3. Chimney Repairs - (Revised Update)

Cathedral Courts Conservation Plan Amendment 1

2018-08-22

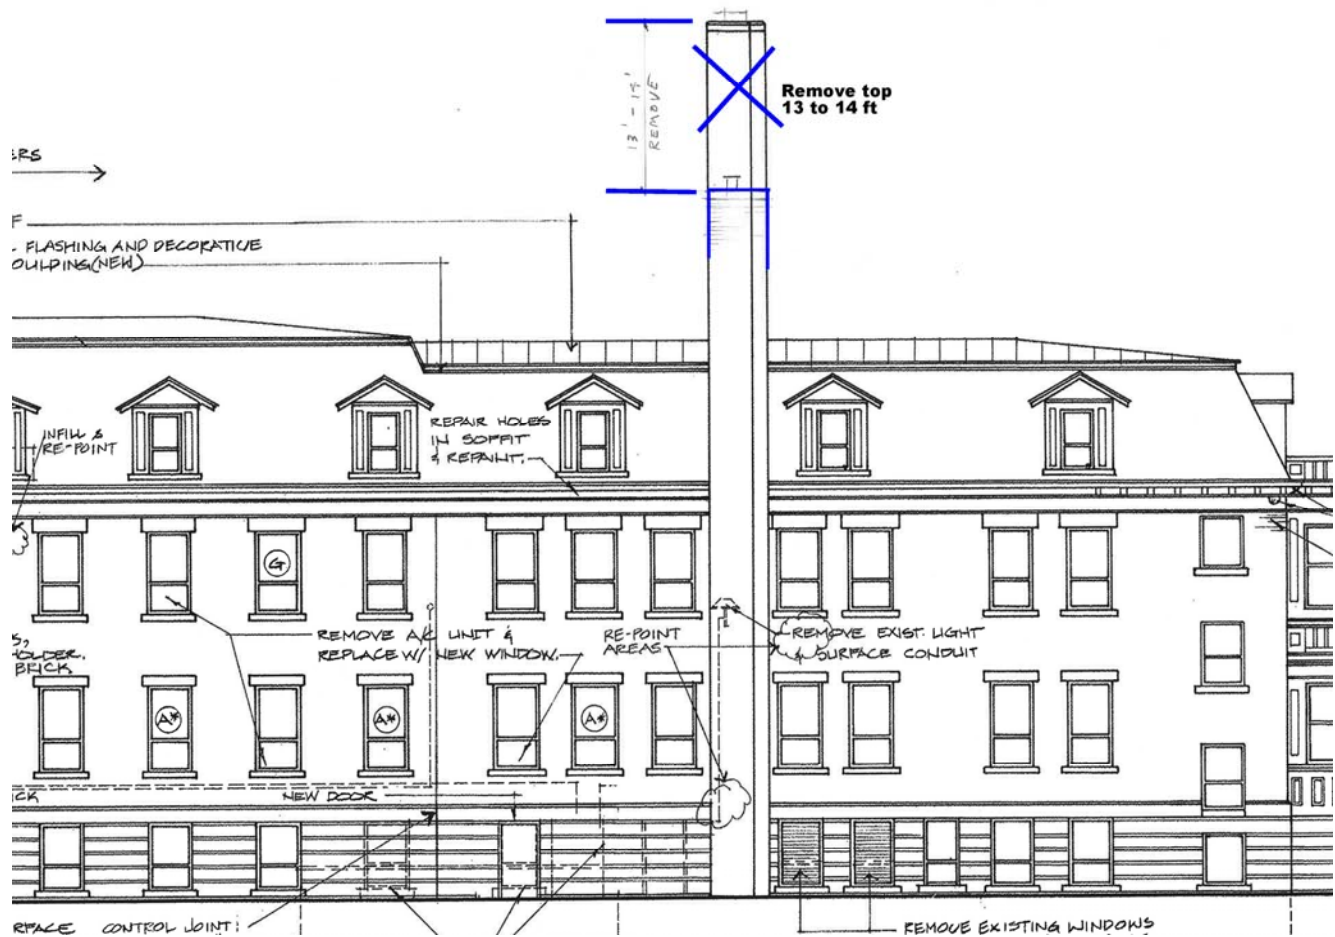
Attached are a few conceptual sketches for consideration. There were several assumptions noted in developing the sketches. Materials and finish of materials will need to be reviewed. Stainless steel offers the most protection to the elements. Galvanized or epoxy coated would be next, but all damaged surfaces need to be repaired or the corrosion concentrates at the point of the imperfection. Rusting surfaces will stain the brick. It may be preferable to match the color / finish / profile to be as least visible as possible.

The reinforcing could be installed in pair, staggered vertically and rotated. It would be prudent to tie the chimney back to the roof.
